List of changes from consented scheme:

Client Sign Off	Approved / Original:	Tate Harmer	Unit 1182, Stamford Works, 3 Gilt Street, London N16 8JH	Do not scale. All dimensions to be checked on site. This drawing is copyright.
	Client:	Platinum Land	8 Overhill House, 1 Duke of York Square, Kings Road, London, SW3 4LX	Date of Origin: 28.11.17
	Project:	Belsize Park Firestation		Drawn By: TS
	Drawing Title:	Proposed Second Floor Plan		Scale: 1:100 @ A1
Drawing Number:	BFS THA PR PA 120 P3	Revision:	Planning

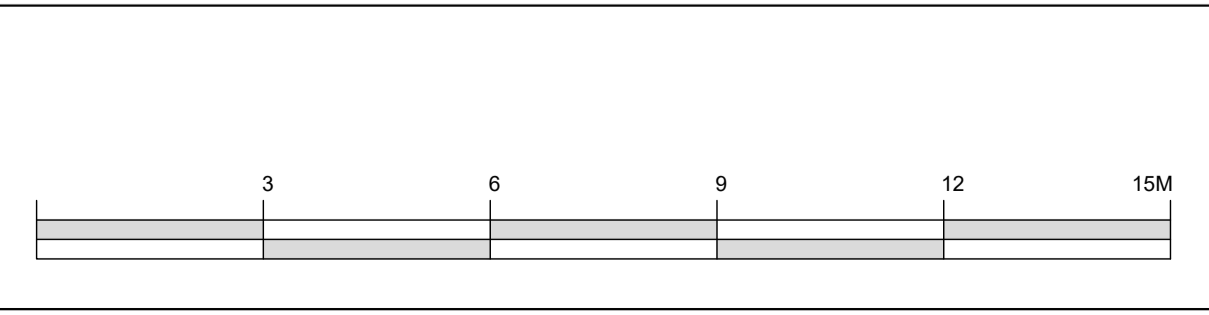
- Unit 9 - Amendment to internal layout. Mezzanine storage area above kitchen.
- Unit 10 - Amendments to internal layout.
- Unit 11 - Amendments to internal layout.
- AOV to replace existing access hatch.
- Repair to roof rafters to strengthen roof.

New AOV to replace existing access hatch
